ADDENDUM #01

ADA Compliance Upgrades Foussat and Libby

BID NO. 2025-21-070B

RFI #1: DWG Review - ADA Scope

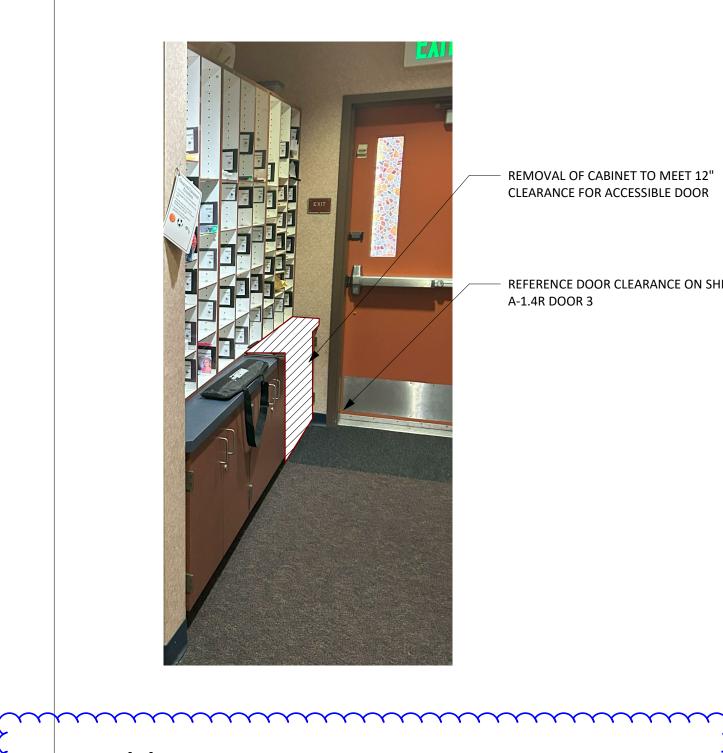
Question Question from James McGrane MAAS on Monday, Apr 7, 2025 at 11:15 AM PDT Please provide clarity on the following inconsistencies found in the DSA approved set: • T1.3R - Two detail #8's • A-1.1R - Kindergarten Drinking Fountain does not appear on Enlarged Site Plan · Callout on POT references OVERALL SITE PLAN for Drinking Fountain rather than A-1.3R for Kindergarten Drinking Fountain (Details) Please confirm that the clouded sheets align with the understanding of work yet to be performed. (Summary of Work narrative attached for reference.) Attachments Screenshot 2025-04-07 114612.png, Screenshot 2025-04-07 115303.png, 01-01-00_Summary_Foussat-ADA.pdf Awaiting an Official Response

Please see the attached sheets for markups clarifying inconsistencies. The two detail #8s on T-1.3R have been renamed to 8A and 8B.

A note has been added to clarify that the drinking fountain details on A-1.3R apply to the kindergarten drinking fountain, called out on the overall site plan.

A-1.0R OVERALL SITE PLAN

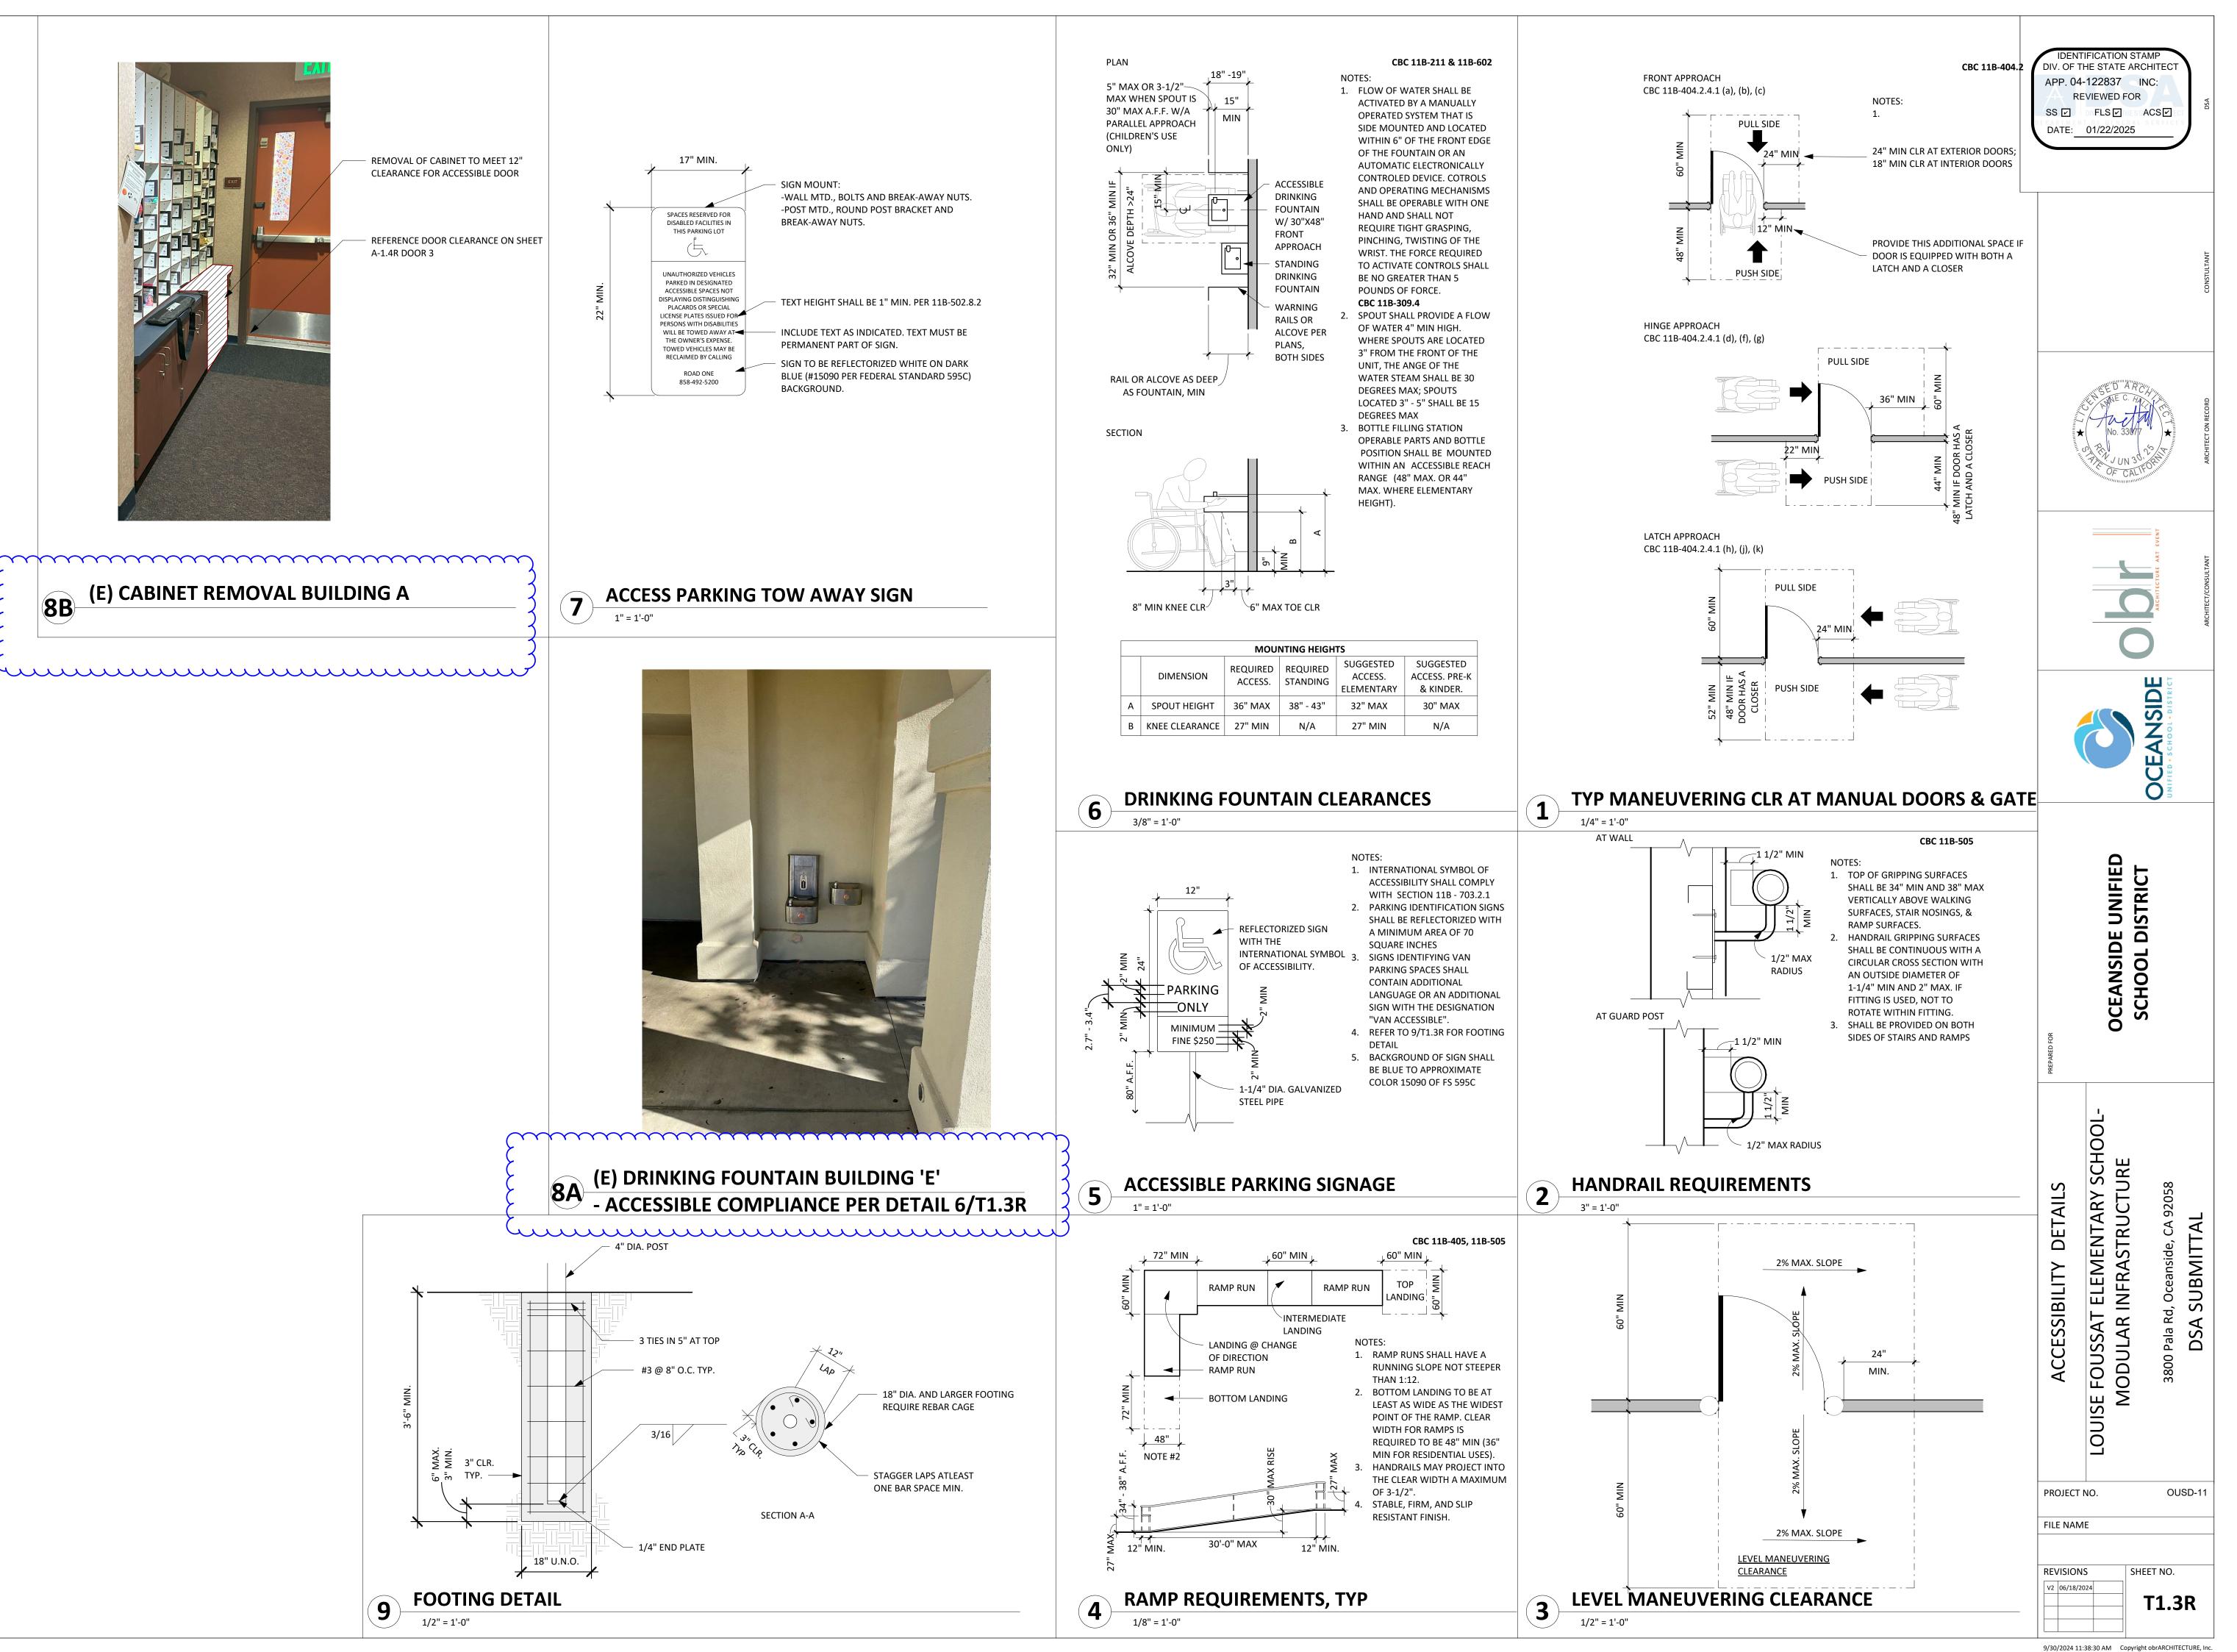
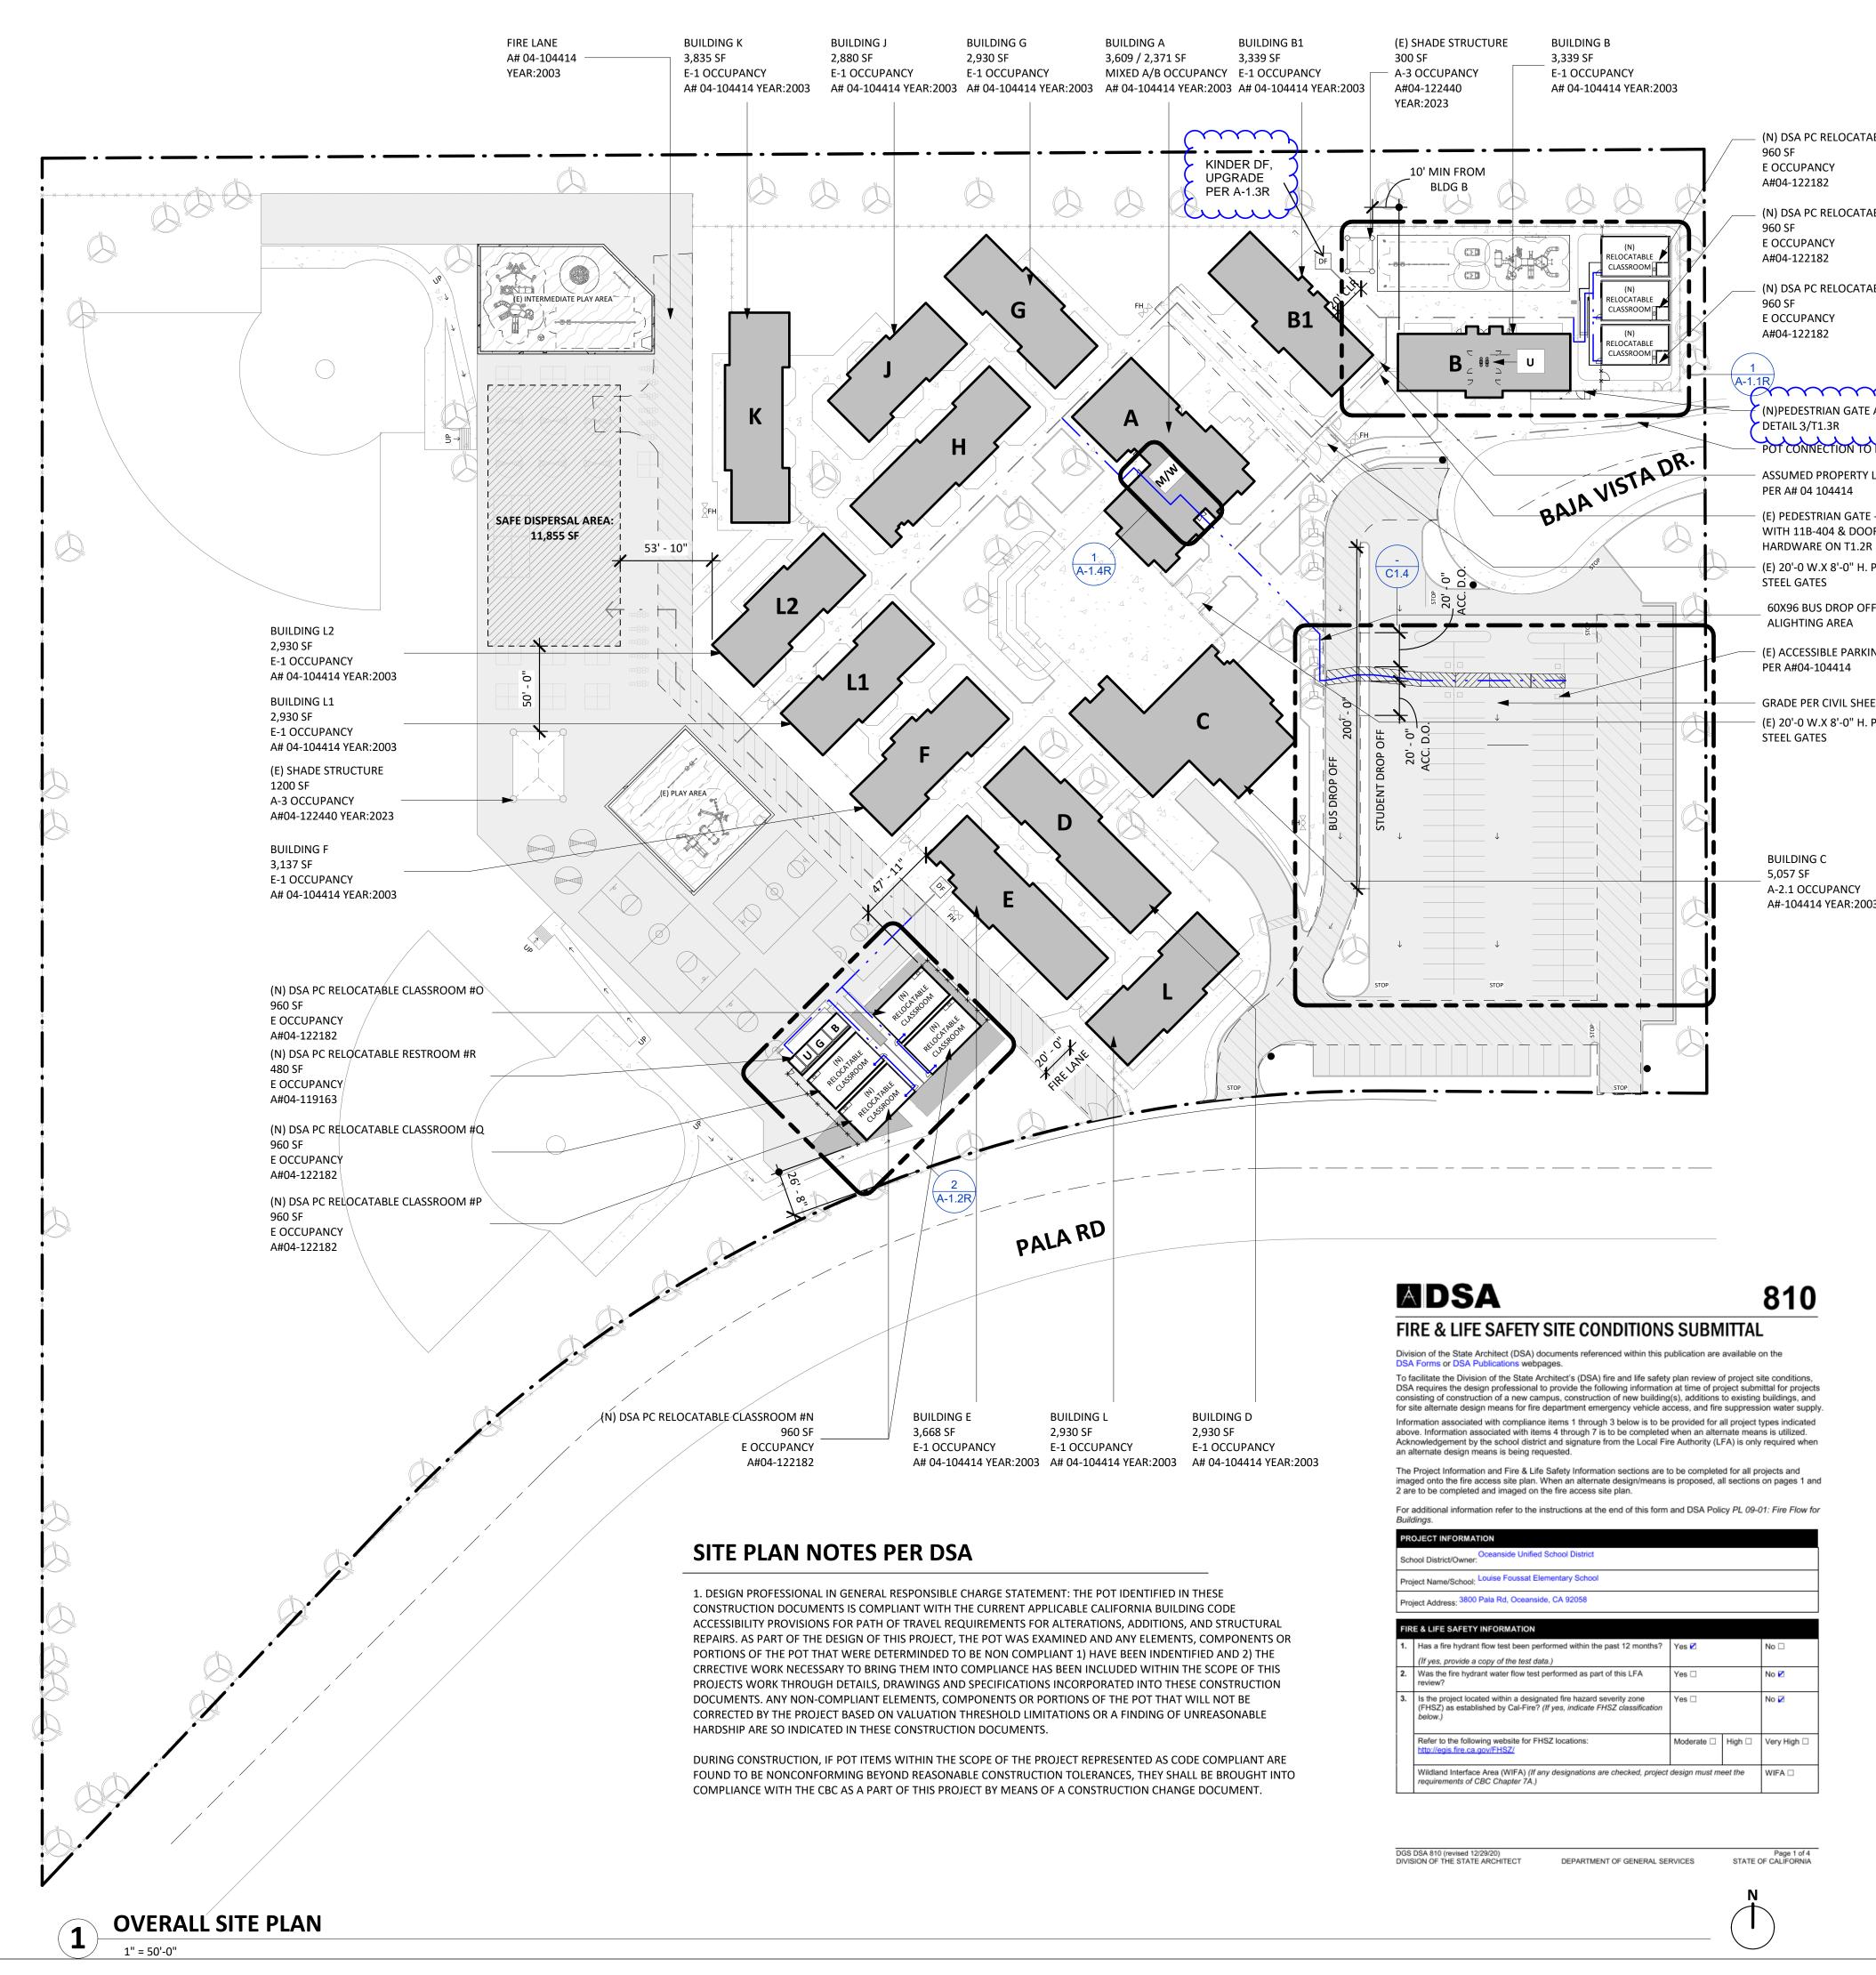
Please note that in review, the reference for A-1.0R to see Detail 4/T-1.3R was noted to be incorrect. This should reference detail 3/T-1.3R as noted on A-1.0R, and should be revised on the first bullet point of the summary.
